(Product Change Notification)

PCN# 071621

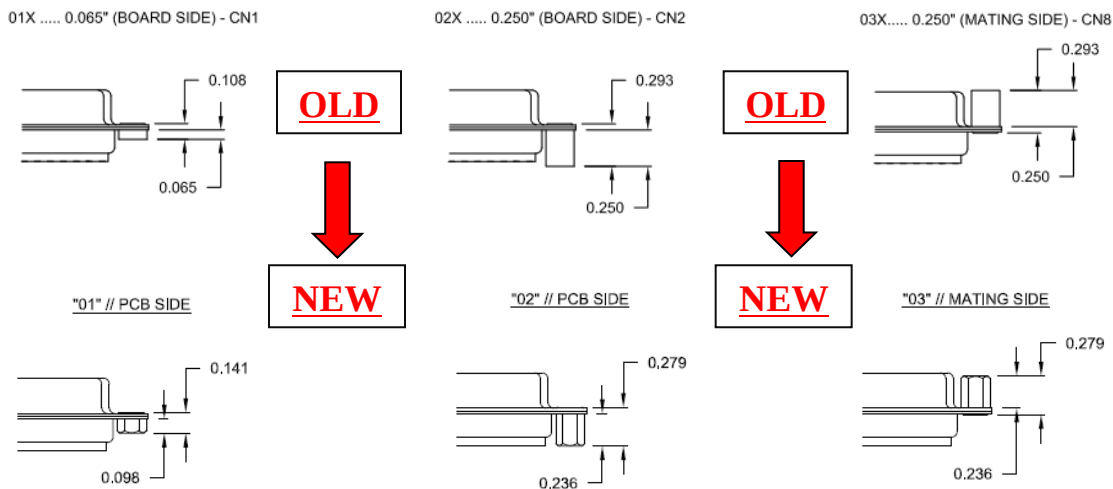
In efforts to improve our quality and match industry standards NorComp has changed the geometry of the hardware associated with the part numbers listed on the subsequent page.

The hardware change pertains to shape and length for the following hardware options shown below. The illustrations below provide a better understanding of the change (all units are in inches). If you have any technical questions, please reach out to eng@norcomp.net.

The last date to purchase the old variation will be Tuesday, February 28th, 2023. All orders placed on/after Wednesday March 1st, 2023 will use the new variant shown above.
